REMARKS

Amendments to the Drawings:

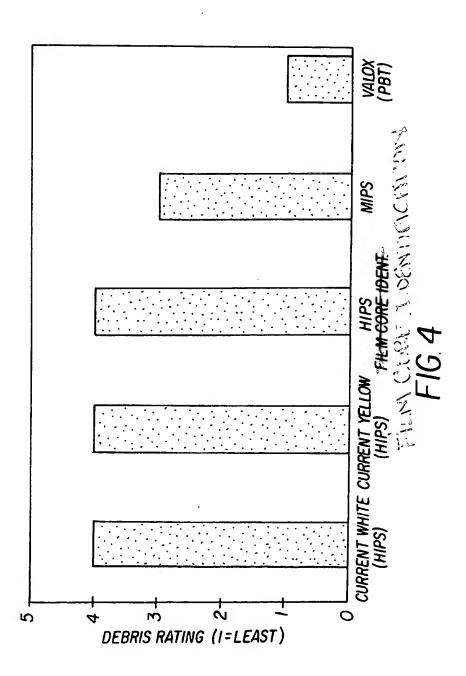
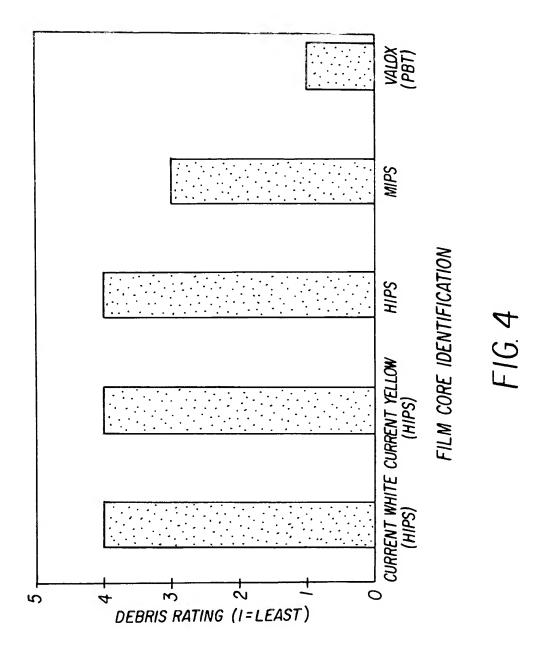
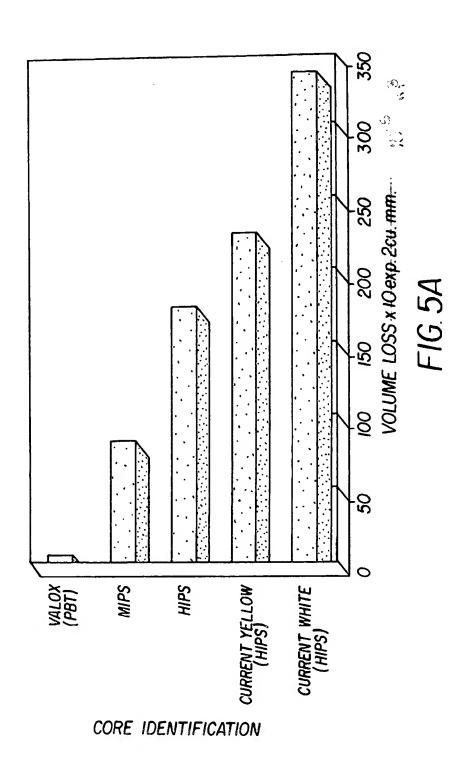
There has been a correction to Figs. 4 and 5A of the drawings which now make the specification and drawings consistent. A marked-up copy of the drawings showing the changes in red are submitted herewith. Approval by the Examiner for the change, is respectfully requested. Formal drawings incorporating the changes are also submitted herewith.

Marked-up copies showing changes in red to Figs. 4 and 5A of the drawings are included at the end of Applicant's response.
